CONSTRUCTION PHOTOS OF EUT

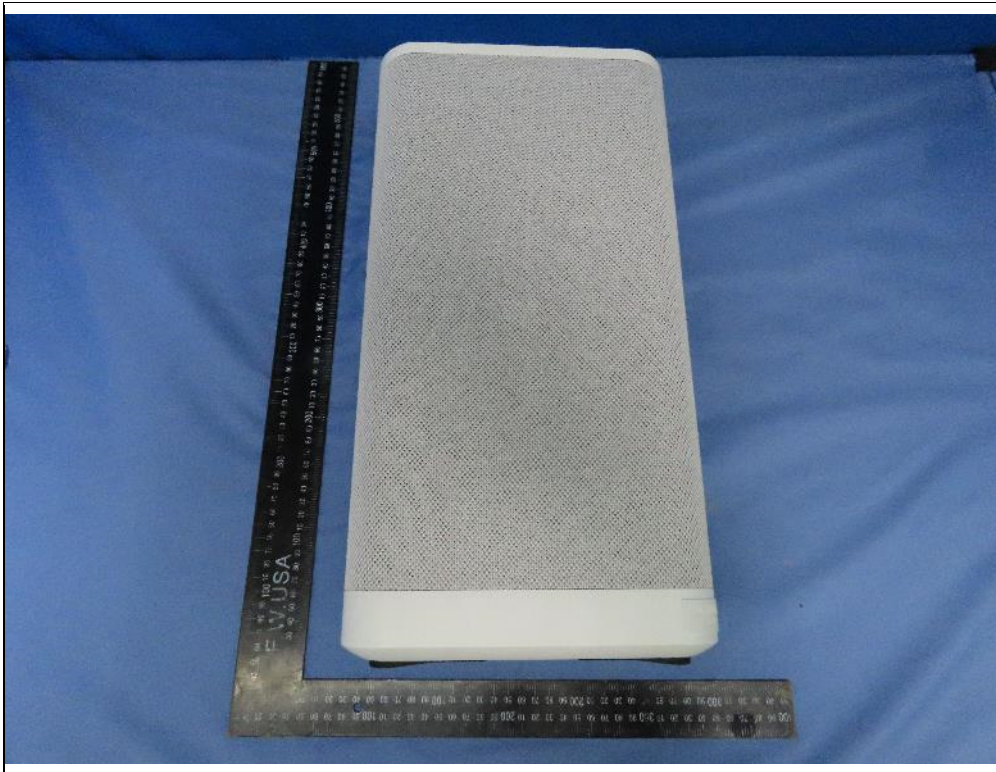
Difference (Change the DC-in Jack and Charge-out port to USB-C)
